# Access Compliance Report

## Public Rights-of-Way

Intersection ID: 10020954	Main Street: BENNETT_WOODS_CT	Cross Street: N/A	Location: NW
ADA ID: CEAAFF707ACB	Ramp Type: Perp	Initial Pass/Fail: Fail	Overall Compliance: No
Severity Score: 10			
Codes/Mitigation Info/Possible Solution		Field Measurements/Component Compliance

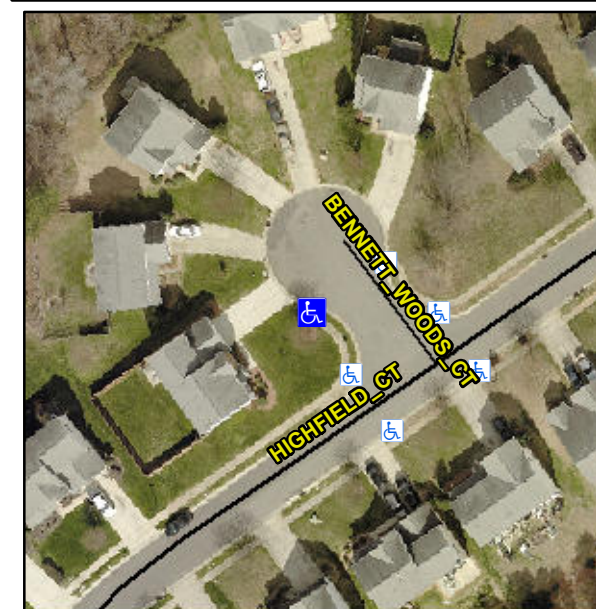
**Not Found, R304.5.1**

Compliance	Description	Data	Compliance	Description	Data
N/A	Ramp Length (in)	35.0	Yes	Ramp Slope (%)	7.6
No	Ramp Width (in)	46.5	Yes	Ramp XSlope (%)	2.7
N/A	Flare Type LT	N/A	N/A	Flare Type RT	N/A
N/A	Flare Slope LT (%)	N/A	N/A	Flare Slope RT (%)	N/A
N/A	Flare Traversable LT?	N/A	N/A	Flare Traversable RT?	N/A
N/A	Landing Length (in)	N/A	N/A	DWS Provided?	N/A
N/A	Landing Width (in)	N/A	N/A	DWS Contrast?	N/A
N/A	Landing Slope (%)	N/A	N/A	DWS Length (in)	N/A
N/A	Landing X Slope (%)	N/A	N/A	DWS Full Width?	N/A
N/A	Landing Curb? (Y/N)	N/A	N/A	DWS Offset (in)	N/A
N/A	Shared Landing?	N/A			
N/A	Gutter Ponding?	N/A	N/A	Gutter Slope (%)	N/A
N/A	Gutter Lip Ht (in)	N/A	N/A	Gutter X Slope (%)	N/A
N/A	Painted X Walk1?	No	N/A	Painted X Walk2?	N/A
	X Walk 1 Direction	To E		X Walk 2 Direction	N/A
N/A	X Walk 1 Width (in)	N/A	N/A	X Walk 2 Width (in)	N/A
	X Walk 1 Slope (%)	4.6		X Walk 2 Slope (%)	N/A
	X Walk 1 X Slope (%)	2.9		X Walk 2 X Slope (%)	N/A

**Remove & Replace Entire Ramp.**
